# Access Compliance Report

## Public Rights-of-Way

Intersection ID: 27673	Main Street: GUNPOWDER_POINT_DR	Cross Street: NOLEN_LN	Location: N
ADA ID: D9AD233997C0	Ramp Type: Perp	Initial Pass/Fail: Fail	Overall Compliance: No
			Severity Score: 52.5

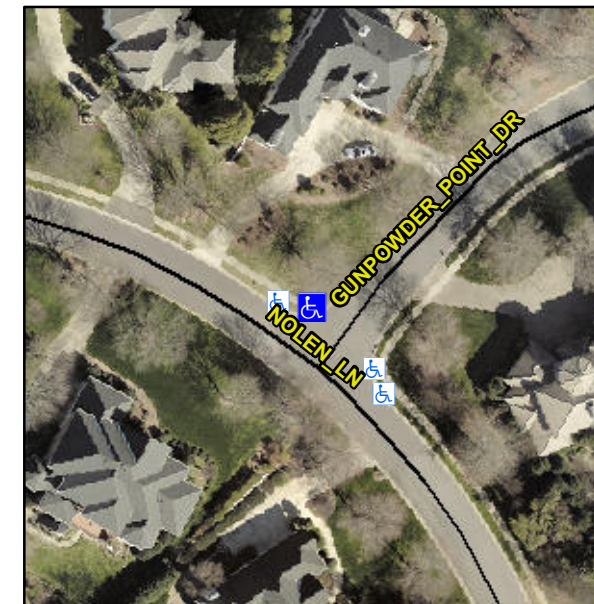
**Not Found, R304.2.2, R304.5.3, R302.7**

Compliance	Description	Data	Compliance	Description	Data
N/A	Ramp Length (in)	50.0	No	Ramp Slope (%)	11.7
Yes	Ramp Width (in)	48.0	No	Ramp XSlope (%)	8.5
N/A	Flare Type LT	N/A	N/A	Flare Type RT	N/A
N/A	Flare Slope LT (%)	N/A	N/A	Flare Slope RT (%)	N/A
N/A	Flare Traversable LT?	N/A	N/A	Flare Traversable RT?	N/A
N/A	Landing Length (in)	N/A	N/A	DWS Provided?	N/A
N/A	Landing Width (in)	N/A	N/A	DWS Contrast?	N/A
N/A	Landing Slope (%)	N/A	N/A	DWS Length (in)	N/A
N/A	Landing X Slope (%)	N/A	N/A	DWS Full Width?	N/A
N/A	Landing Curb? (Y/N)	N/A	N/A	DWS Offset (in)	N/A
N/A	Shared Landing?	N/A			
N/A	Gutter Ponding?	N/A	N/A	Gutter Slope (%)	N/A
N/A	Gutter Lip Ht (in)	N/A	N/A	Gutter X Slope (%)	N/A
N/A	Painted X Walk1?	No	N/A	Painted X Walk2?	N/A
	X Walk 1 Direction	To SE		X Walk 2 Direction	N/A
N/A	X Walk 1 Width (in)	N/A	N/A	X Walk 2 Width (in)	N/A
	X Walk 1 Slope (%)	5.8		X Walk 2 Slope (%)	N/A
	X Walk 1 X Slope (%)	5.6		X Walk 2 X Slope (%)	N/A

**Remove & Replace Entire Ramp.**
